# UNITED STATES PATENT AND TRADEMARK OFFICE

APPLICATION NO.	FILING DATE	FIRST NAMED INVENTOR	ATTORNEY DOCKET NO.	CONFIRMATION NO.
10/010,243	12/06/2001	Scott C. Sanner	7784-000356	5792

# Office Action Summary

FIG. 2  
PRIOR ART

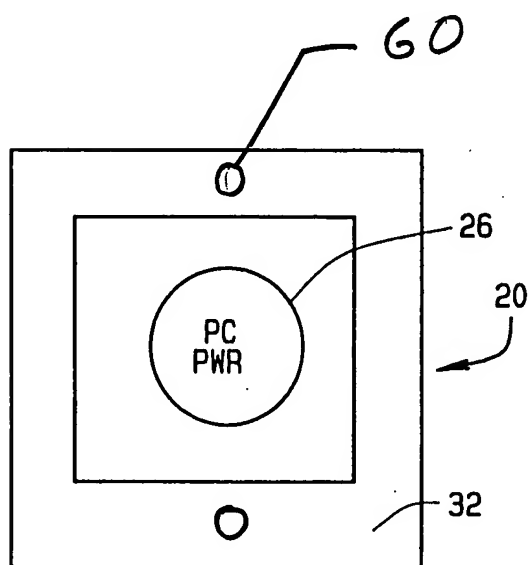
Use of existing attachment means is basic to the inventive concept but is not shown in a clear manner. For claim 2, prior art cover is shown in fig. 2. The fig. 4 covers appear to be of "different dimensions" rather than of the same dimensions as the fig 2 cover. For claim 2, in this regard, would seem to require a cover like that of fig 2 in size but with "additional connectors" mounted thereon. Is such cover part of intended invention? If so it should be more clearly discussed in the spec. For existing attachment feature, see sketches of plates with holes 60 for screws shown for both old and new covers. This feature could be added to figs. with added discussion in spec. and with indication that such faceplate holes for screws are standard in the art. Other structures could be used to show this aspect <sup>if</sup> more appropriate.

FIG. 3  
PRIOR ART

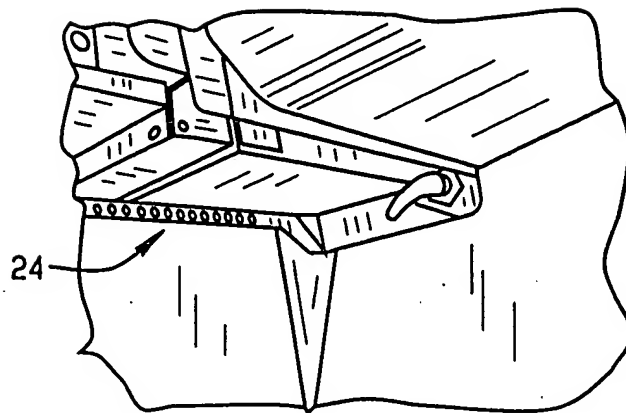
Spec. For fig. 3, power box mounted "under seat should be added if that is true.
